**City of Portland, Oregon**  
**Bureau of Development Services**  
**Land Use Services**

**NOTICE OF A TYPE Ix DECISION ON A PROPOSAL IN YOUR NEIGHBORHOOD**

**CASE FILE NUMBER: LU 14-242277 HR**  
**STOREFRONT ALTERATIONS AND NEW SIGNAGE**

**Site Address:** 811 SW NAITO PARKWAY

2 AREAS OF PROPOSED WORK  
N/S

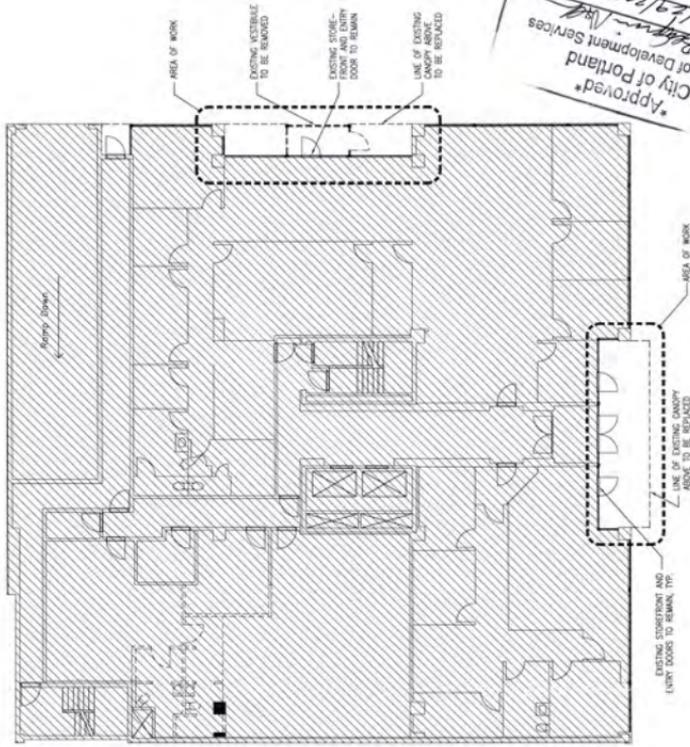
SEE CONDITION OF APPROVAL C.

- C. The parapet wall sign shall be centered in the middle, recessed bay over the building entry facing Naito Parkway and without lighting of any kind. The sign shall be pin-mounted through the grout lines only and of the same material and dimension (6'-6" wide by 3'-2" tall) as that proposed originally for the corner of the parapet. The sign may be either mounted up to 1-1/2" from the face of the building as was originally proposed, or it may be mounted flush with the building in a method identical to the address wall sign.

PROPOSED SW NAITO PKWY. CANOPY AND CORNER BLADE SIGN

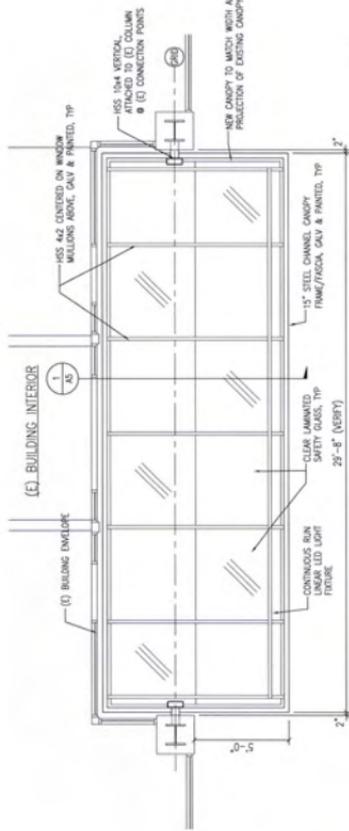
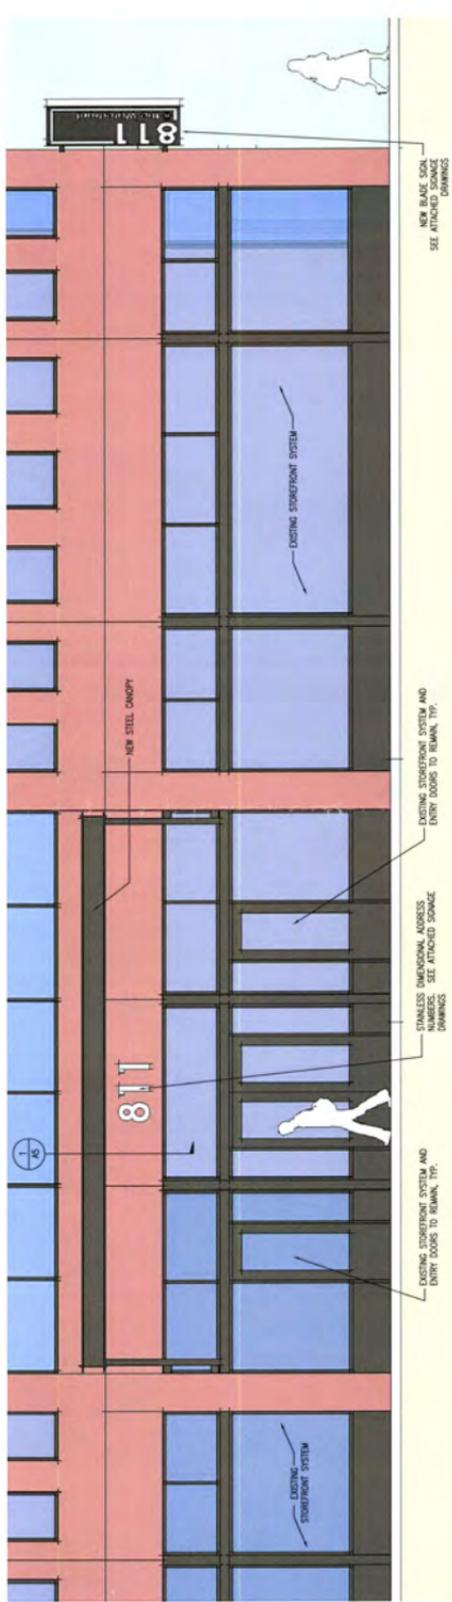
The blade sign at the corner of the building will be installed with the body of the sign between the top of the storefront system on the ground floor and the base of the punched window openings on the second floor, with the base 11' above the sidewalk. The sign will be comprised of an aluminum cabinet which is mounted on aluminum brackets that will attach to either side of the corner of the building at both the top and the bottom of the sign and all of which are painted satin black to match the storefront system. The lag bolts attaching the brackets to the building will penetrate only at existing grout lines in the façade. The face of the sign measures 3'-0" wide x 7'-0" tall and sits 8" out from the face of the building. The sign is 4-1/4" thick.

The sign will be lit externally from above via a lighting armature (drawn correctly on FFA Sheet A6 but identified incorrectly on TAG Sheet 4 of 4 as an LED light bar). No exposed electrical conduit or junction boxes are shown, or allowed.

- B. The corner blade sign and associated lighting shall have no electrical conduit or junction boxes exposed on the exterior of the building, and the lag bolts attaching the sign brackets to the building penetrate only at the grout lines

**Manufacture and install one (1) set of halo illuminated channel numbers**

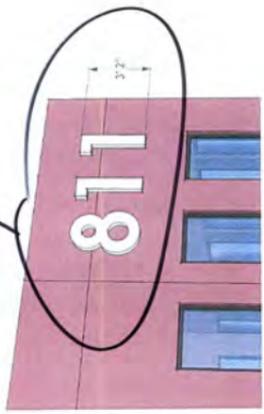
The parapet wall sign that is proposed at the north corner of the east façade of the building is comprised of brushed stainless steel pin-mounted numerals, which are attached only through the grout lines between the brick. They are 3'-2" tall and 3-1/2" deep. The numerals would be set off the face of the building by 1-1/2". The total length of the parapet sign is 6'-6" and total area is approximately 20.6 square feet. The sign would be halo-lit by white LEDs which are hidden in within the numerals and which project their light on the building façade behind the sign. The electrical connection would be located behind the parapet.

Staff does not support either the location or the lighting of this sign as proposed. The proposed location at the corner of the parapet is inconsistent with the character of other signs in the Yamhill Historic District: there are no other buildings within the District which have signs located near the top and corner of a building, and signs in this location would not be "visually compatible with the traditional architectural character of the historic buildings in the District." There is precedent within the District for signage on the pediments of several buildings within the District,

SEE CONDITION OF APPROVAL C.
